**EPA Superfund
Explanation of Significant Differences:**

**COMMENCEMENT BAY, NEAR SHORE/TIDE FLATS
EPA ID: WAD980726368
OU 01
PIERCE COUNTY, WA
06/24/1993**

EXPLANATION OF SIGNIFICANT DIFFERENCES

Sitcum Waterway Problem Area of the Commencement Bay Nearshore/Tideflats Superfund site, Tacoma, Washington. Operable Units 01 and 05--Contaminated Marine Sediments and Sources, respectively.

FIGURE 1

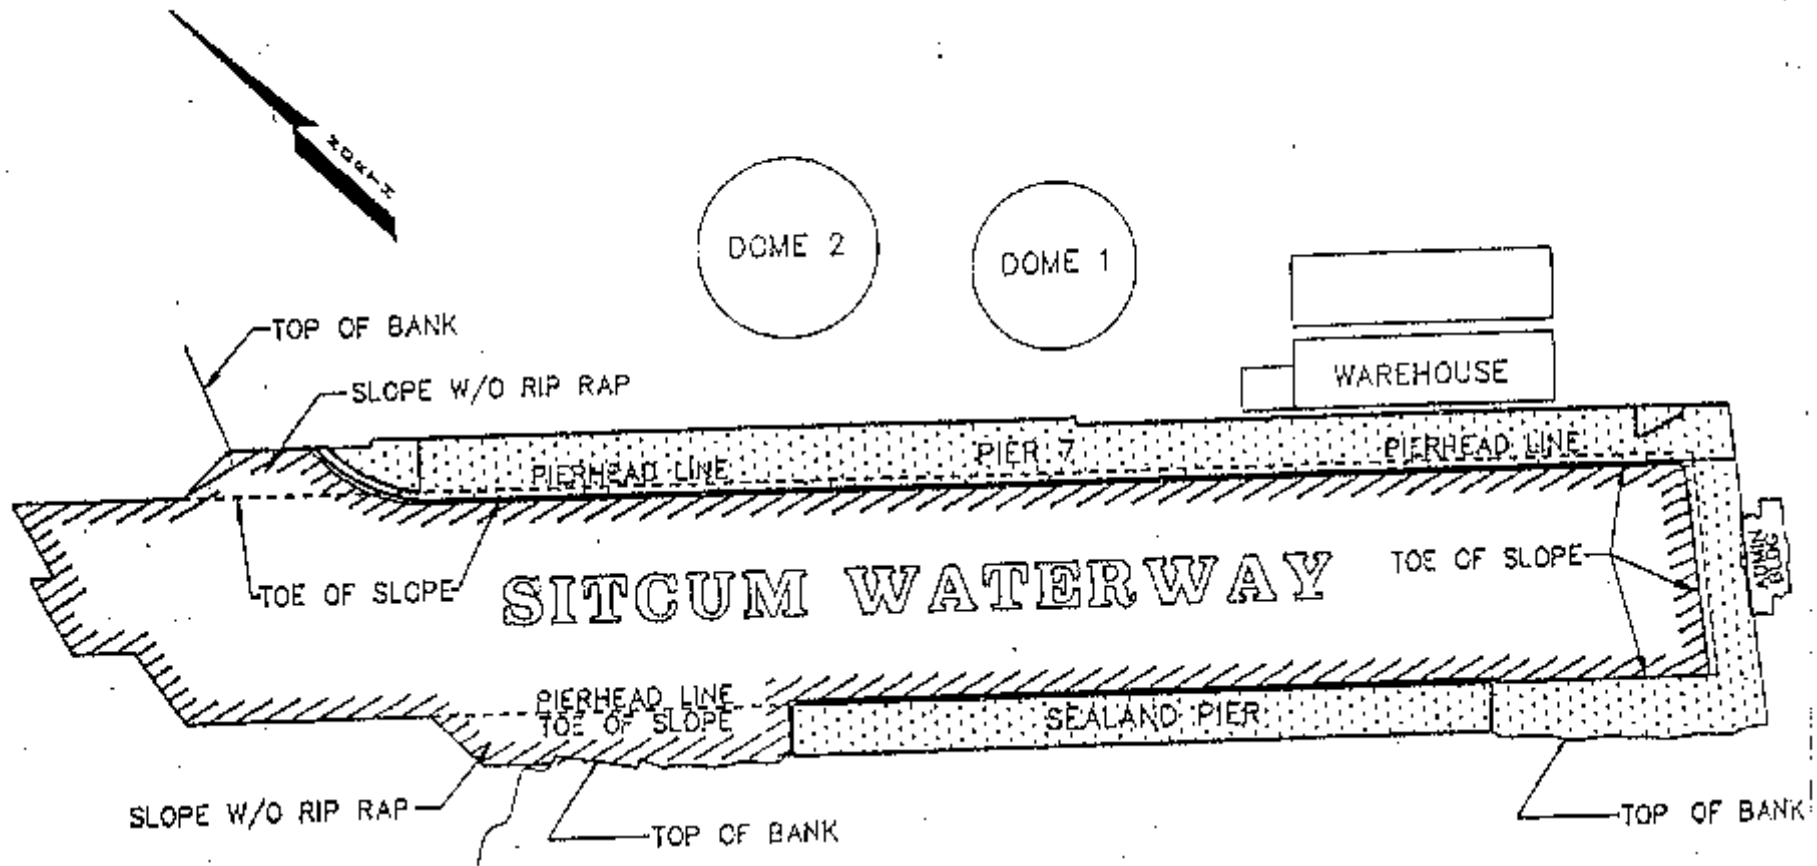
See figure 1 for the map that delineates Phase 1 channel sediments and Phase 2 peripheral sediments. Description of the Phase 1 and Phase 2 areas follows:

Phase 1 area is the bottom sediment of Sitcum Waterway, limited on three sides by the existing rip rap at the toe of the banks and at the mouth of the waterway where the existing channel bottom drop's off to the deeper portions of the Bay. Also included in Phase 1 are the slopes which have no rip rap and are located bayward of the existing Sea Land Pier and the northwestern rail trestle leading to Pier 7.

Phase 2 area is the rip rap covered existing slopes, both exposed and under pier. The slopes are from the bay end of the Sea Land pier to and including the head of the waterway, and all slopes under Pier 7 including those surrounded by the rail trestles at each end of the pier.
